Subject: Transmittal of Class 1 Permit Modification to Make Updates at Technical Area 54, West Indoor Unit in the Los Alamos National Laboratory (LANL) Hazardous Waste Facility Permit, EPA ID No. NM0890010515

Permit Modification Notification

Revisions and Figure Updates for Attachments A, G.16 and N

Figure G.16-2: Technical Area 54, Building 38 (High and Low Bay) Additional Sampling Locations

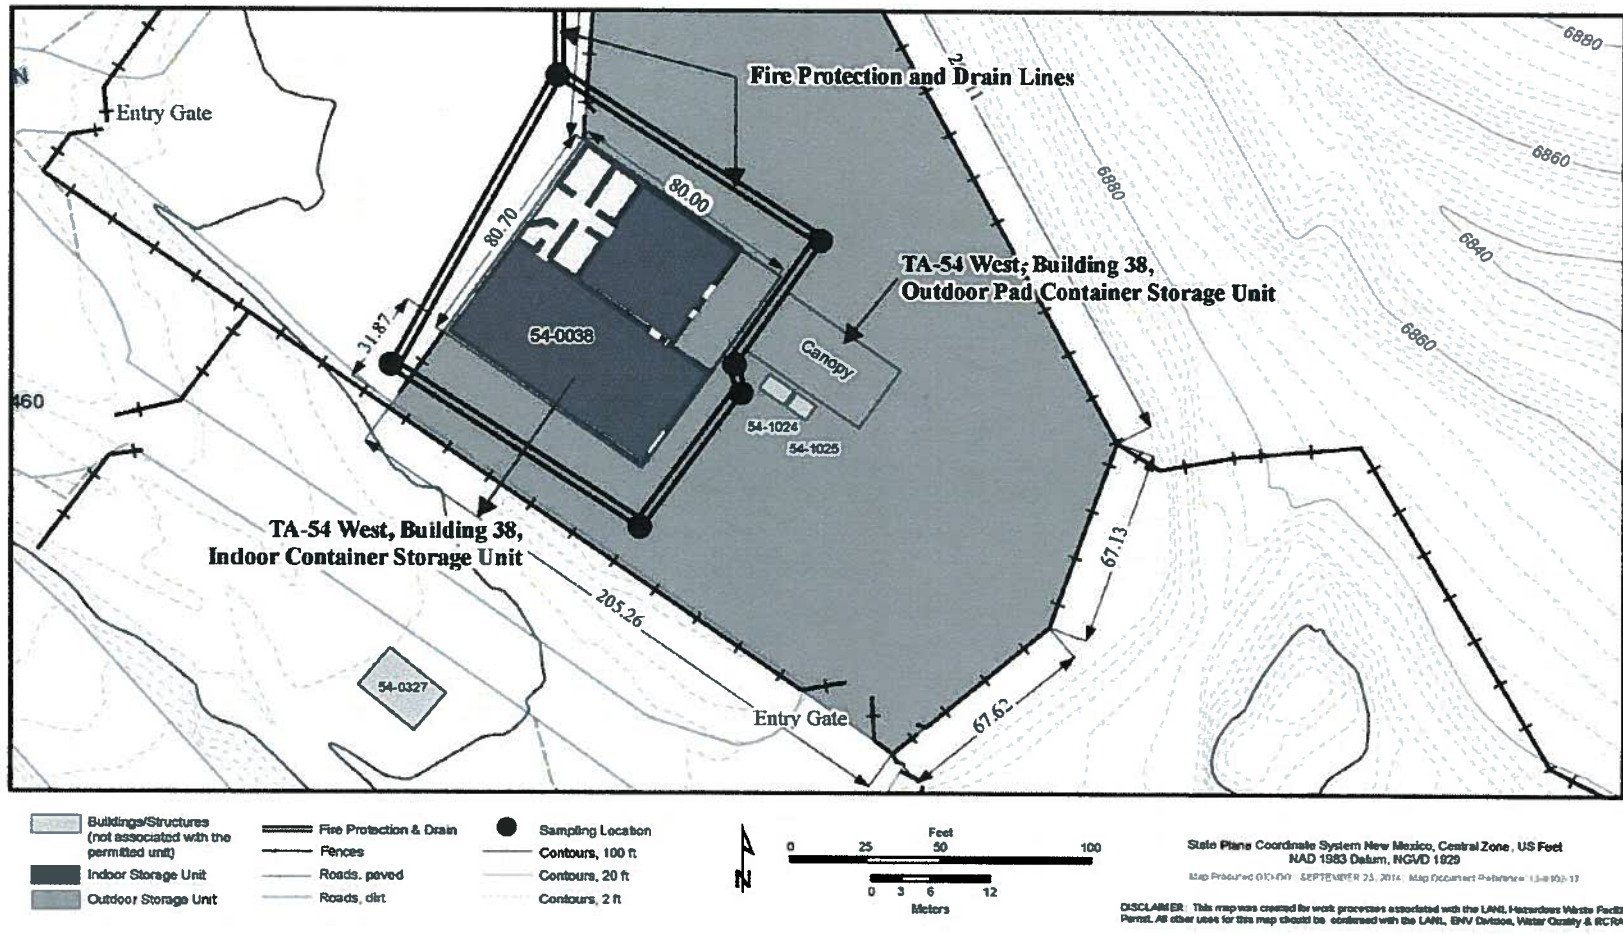
This Class 1 Permit Modification revises the following: a figure in Attachment N (Figure 37); descriptions to Section 2.1 of the closure plan; a figure to Attachment G.16 *Technical Area 54 West, Building 38 Indoor Container Storage Unit Closure Plan*; and adds descriptions of the fire protection drain lines to Section A.4.3.1 in Attachment A, *TA- Unit Descriptions*. The most recent version of Figure 37 that was submitted on June 10, 2014 was used to update these changes and to create the new figure in the closure plan.

This modification adds drain lines within and to the outside perimeter of TA-54-38 that flow to a collection system outside of the unit boundary. The system was designed to collect firefighting and fire suppression water releases from TA-54-38 and is designed to discharge the fire water directly to a fire water retention pond, per DOE-STD-1066-2012 and NFPA 801. The RANT fire water retention pond has been sized for a holding volume to exceed a 30 minute fire suppression water discharge. A collection trench collects the fire water and travels through an underground pipeline that discharges into a fire water retention pond. The pipeline is sloped to provide gravity flow. The water collected in the pond is then sampled prior to release.

Text has been added to A.4.3.1 for consistency with the drain and fire water collection requirements at the TA-63 Transuranic Waste Facility (TWF). Sampling locations and the depiction of the drain lines in Figure G.16-2 and Figure 37 have been modeled after the Figure G.10-1 and Figure 28 for TA-54, Area G, Pad 9. Attachment N, Figure 37 has been updated to reflect the pond and drain lines and Figure G.16-2 has been added to reflect the drain lines and sampling locations for those drain lines at the time of closure.

1. four from the floor;
 2. one from each wall; and
 3. one from the sump;
- b. six wipe samples from the Low Bay (*see* Figure G.16-1):
1. two from the floor; and
 2. one from each wall
- c. The captured fire suppression and firefighting water released from the building conveys in an underground pipeline that discharges into a fire water retention pond. In compliance with Permit Section 9.4.7.1.ii, this closure plan will ensure the collection of soil samples in the following location:
1. One sample at the joints and intersections of the fire water collection system piping
